# UNITED STATES PATENT AND TRADEMARK OFFICE

APPLICATION NO.	FILING DATE	FIRST NAMED INVENTOR	ATTORNEY DOCKET NO.	CONFIRMATION NO.
10/578,705	05/10/2006	Simon Klippel	22353EUS	3688
56851 7590 06/27/2007 TYCO ENGINEERED PRODUCTS & SERVICES ATTN: INTELLECTUAL PROPERTY LAW DEPARTMENT 9 ROSZEL ROAD PRINCETON, NJ 08540			EXAMINER CHAN, KO HUNG	
			ART UNIT 3632	PAPER NUMBER
			MAIL DATE 06/27/2007	DELIVERY MODE PAPER

**Office Action Summary**

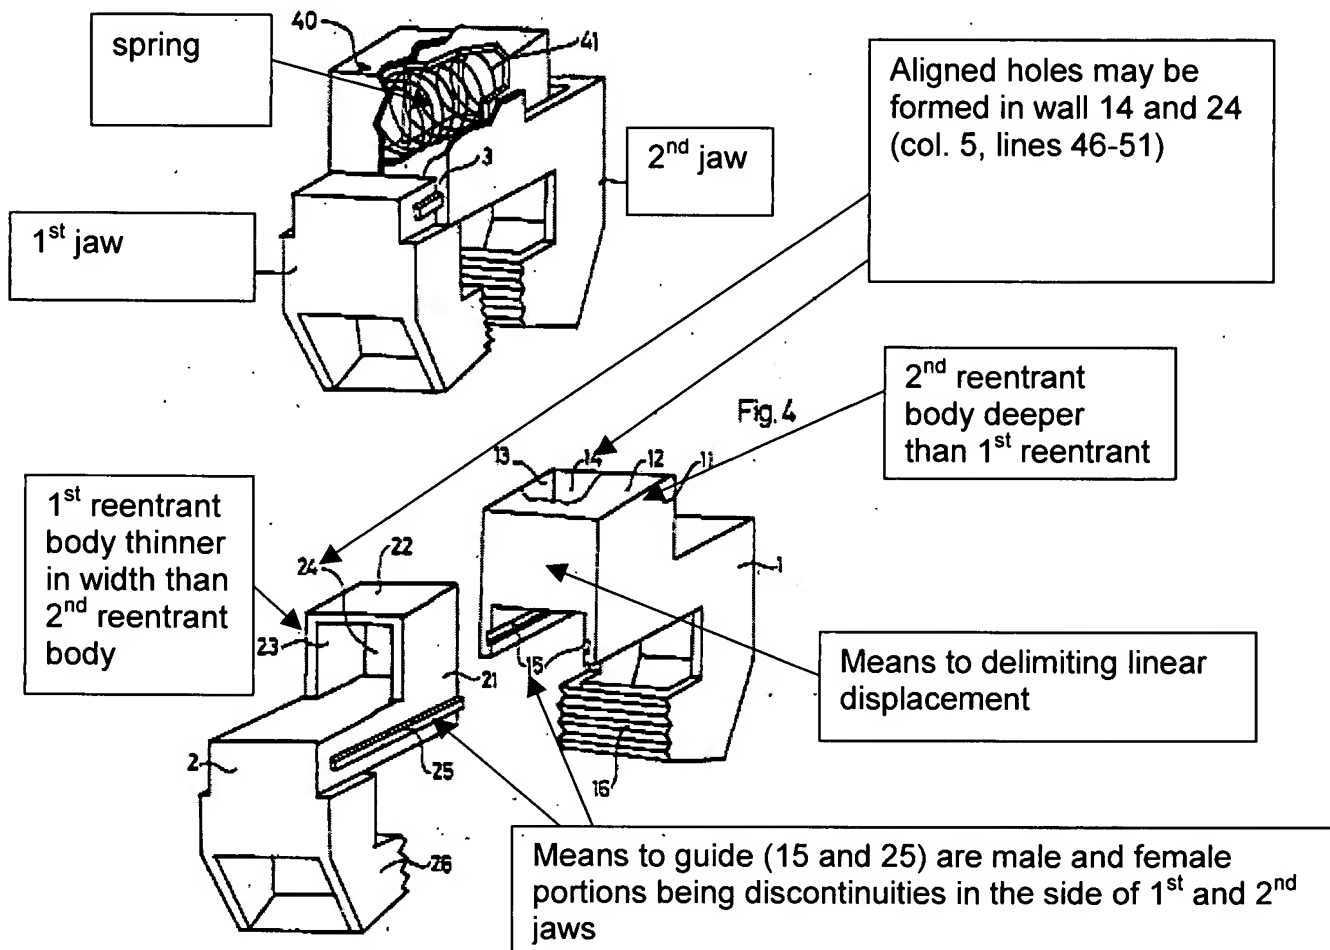
Claims 1-6 and 8-17 are rejected under 35 U.S.C. 102(b) as being anticipated by Rubik (US patent no. 5,042,118). Rubik discloses a clamp comprising all the claimed features of applicant's invention as illustrated below. In addition, Rubik discloses first aperture and second aperture collinear with the first aperture (not labeled or shown in detail but discussed aligned hole in walls 14 and 24, col. 5, lines 46-51).

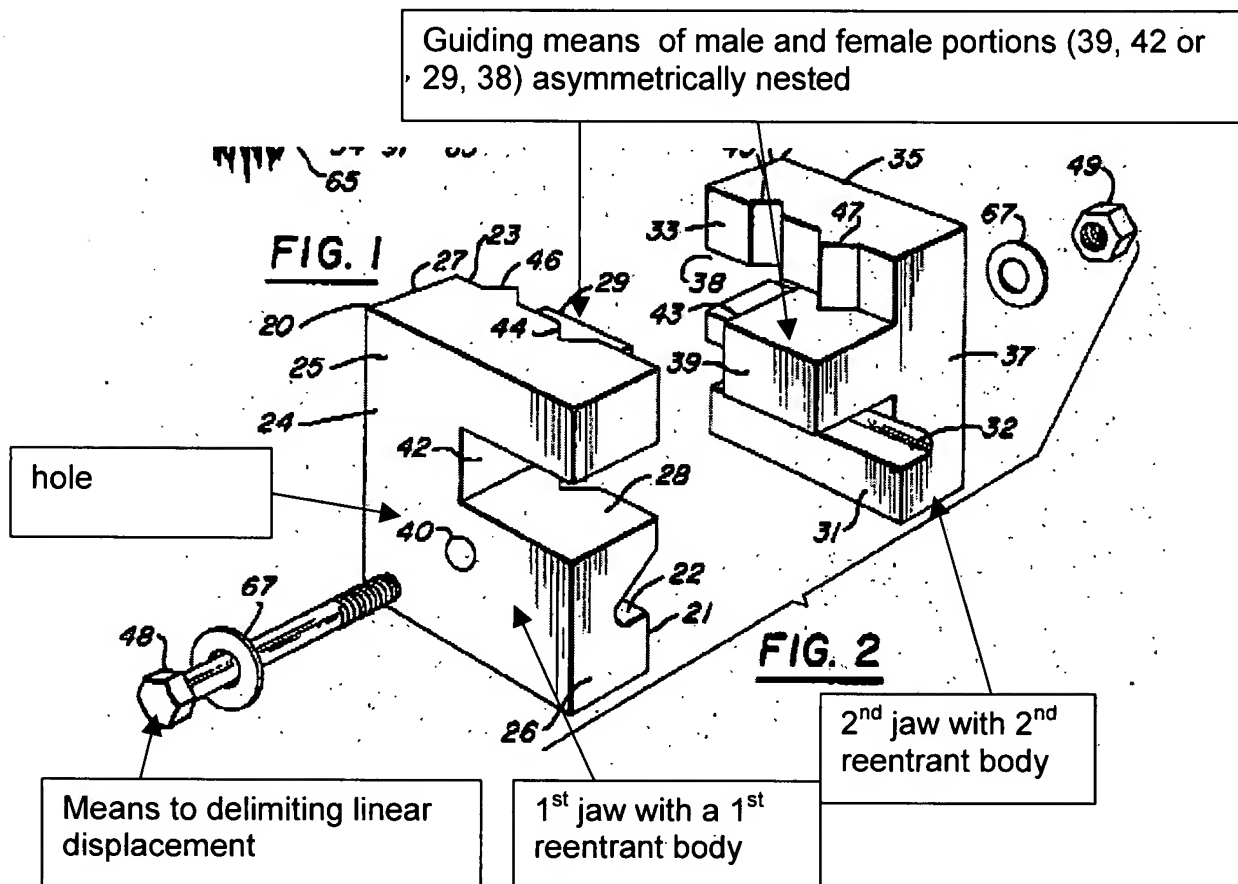
Claims 1-3, 7-10, 13-16, are 18 are rejected under 35 U.S.C. 102(b) as being anticipated by Welch (US patent no. 3,368,782). Welch discloses a clamp comprising all the claimed features of applicant's invention as illustrated below where in first and second jaws are asymmetrically nested within each other.
